PROPOSED
FOUNDATION PLAN

Project: 57 Inlet View
 Location: Sanford, NC
 Company: Frey's Building and Remodeling
 Care of: Scott Frey
 Subject: Structural Notes
 Job No.: 0434-20

STRUCTURAL NOTES
 SCALE: NOT TO SCALE
 PRINT ON 11"x17" PAPER
 PE SEAL FOR
 STRUCTURAL. ONTY

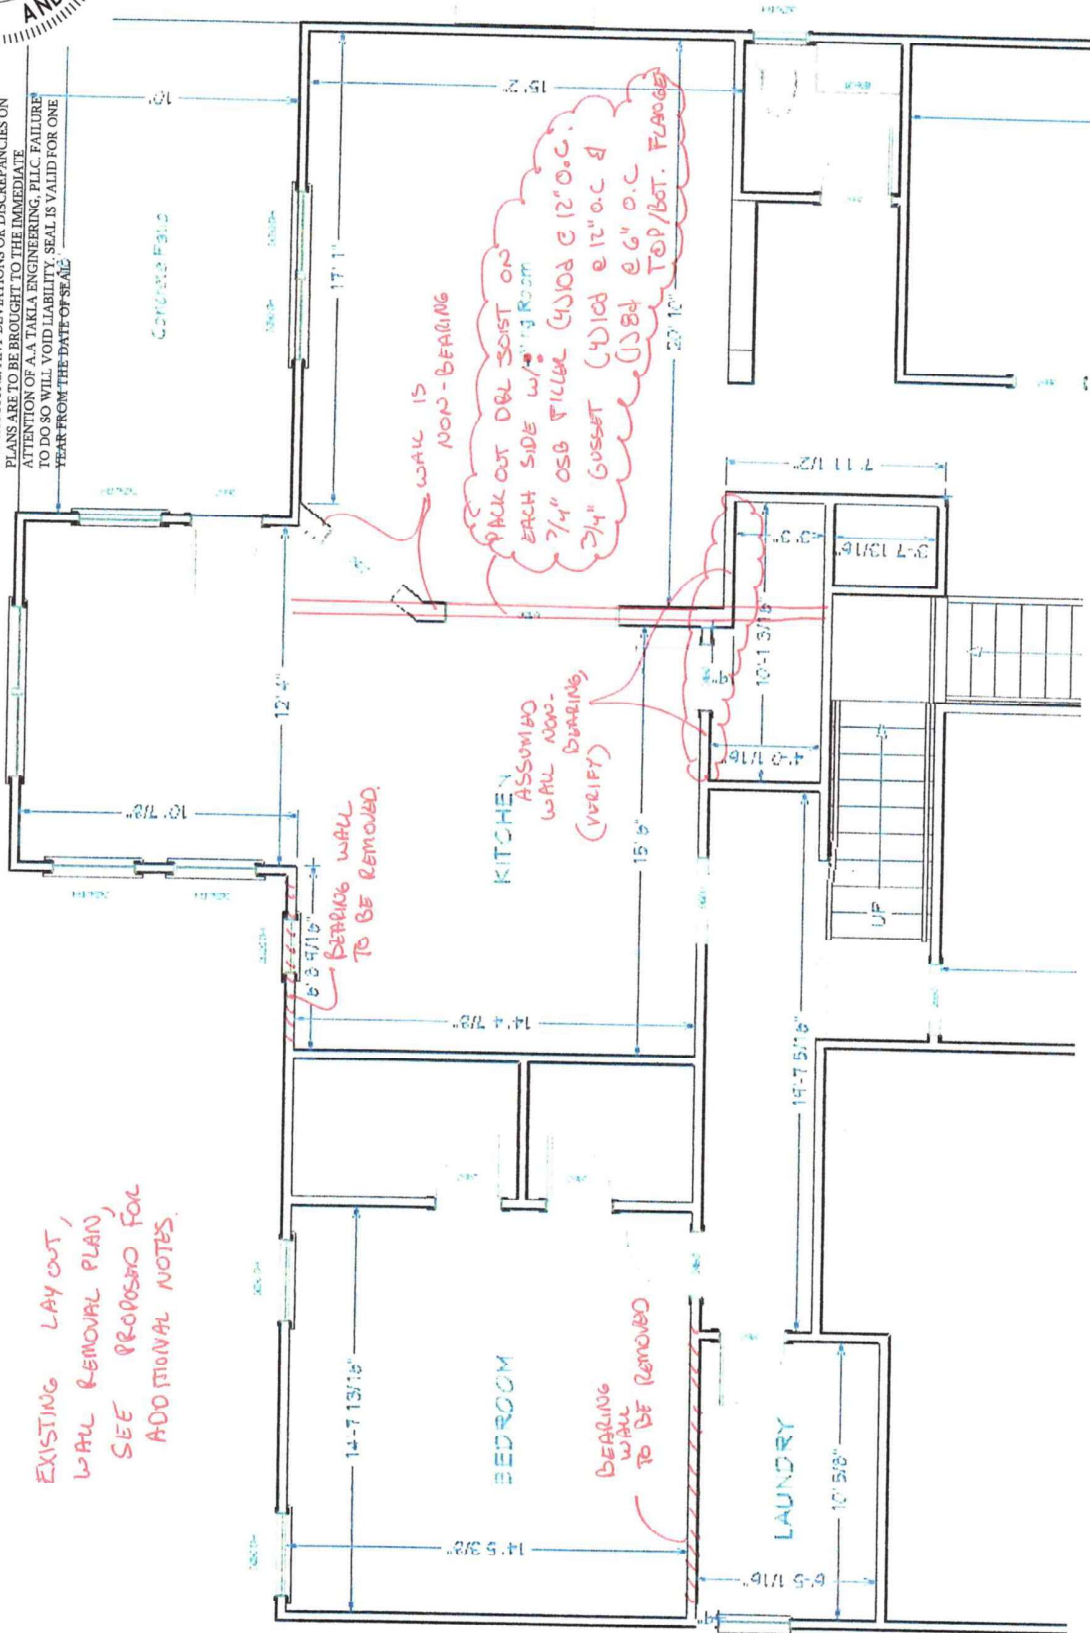
SAW CUT SLAB,
DOWEL IN
EACH
DIR. (ARABIC)
AND PAUL
LARGE FTG.
TYP & ALL
EXPANDED
(FOOTING)

12" L006 #4
EPOXY BORED
PIERS w/
1/2" BEDDIMENT
INTO EXISTING
SLAB
(16" O.C.)

EXPAND FTG TO
38" x 38" x 12"

EXISTING LAYOUT,
 WALL REMOVAL PLAN,
 SEE PROVISION FOR
 ADDITIONAL NOTES.

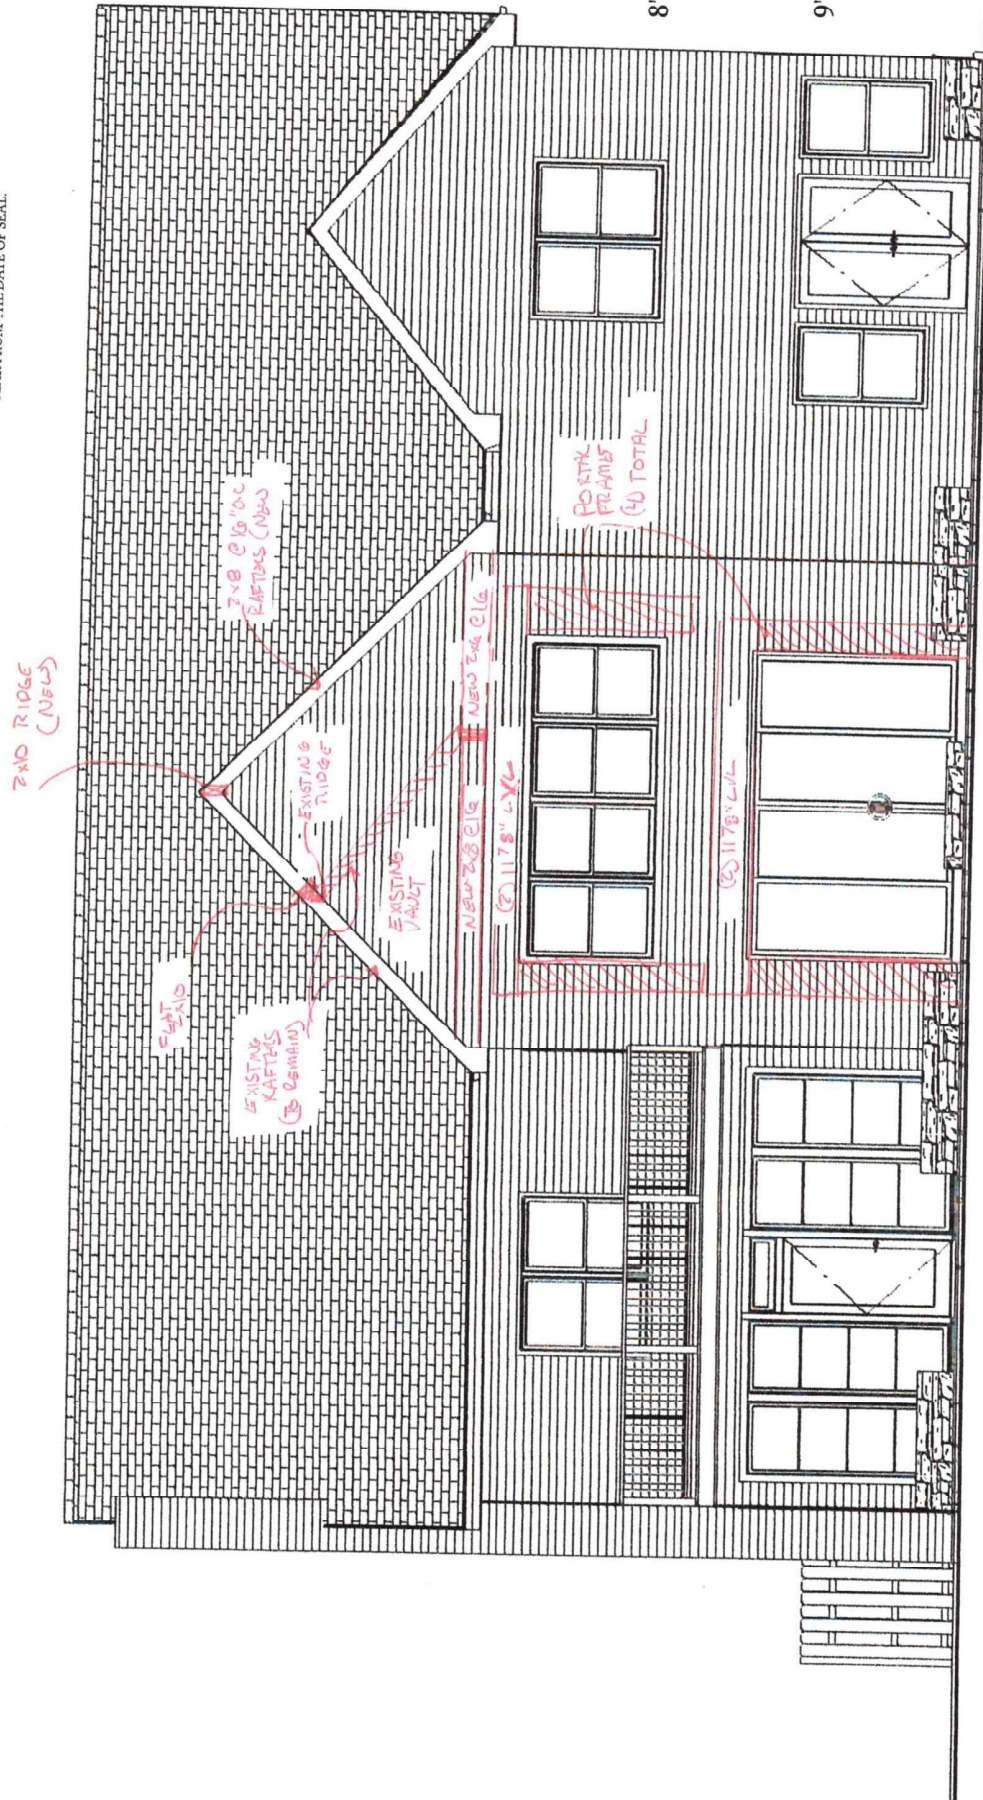
WALLS TO
BE REMOVED

COLUMN
TO REMAIN

NEW LOOF FRAMING
 SECTION

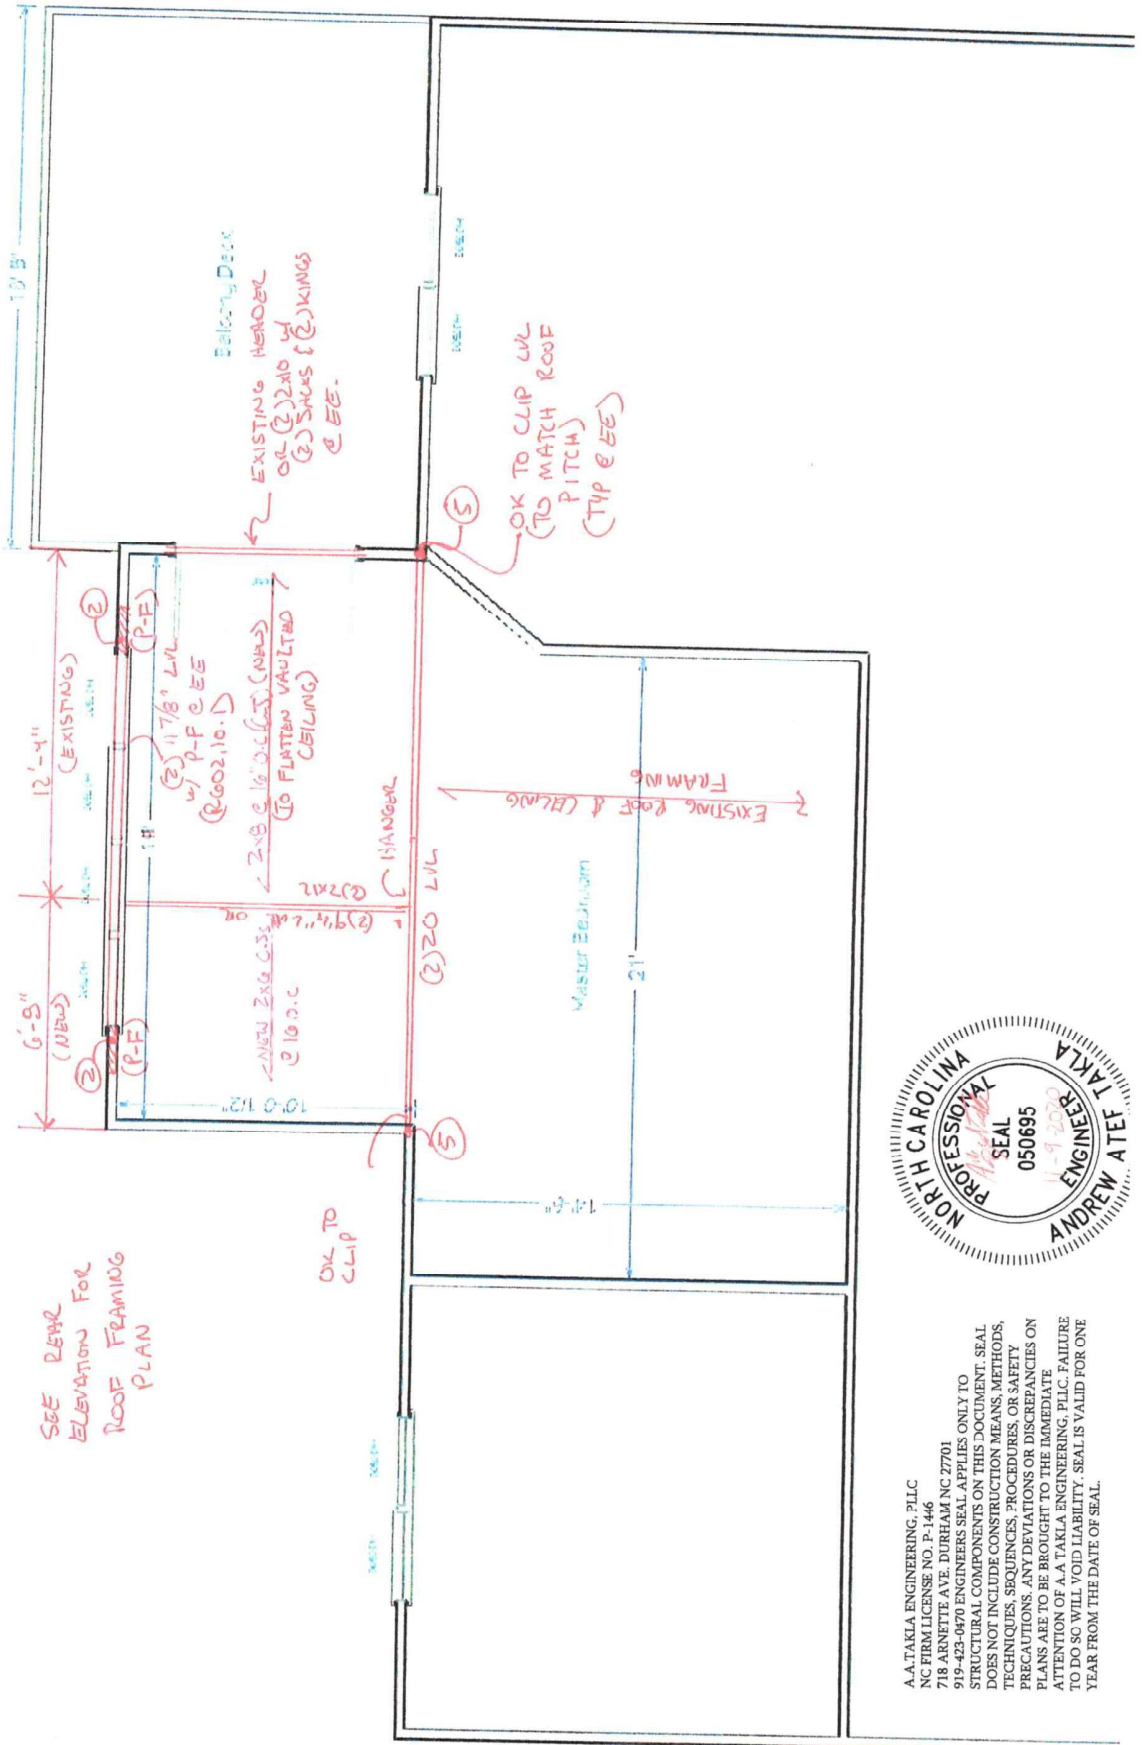
2nd STORY CEILING FRAMING

SEE REAR ELEVATION FOR ROOF FRAMING PLAN
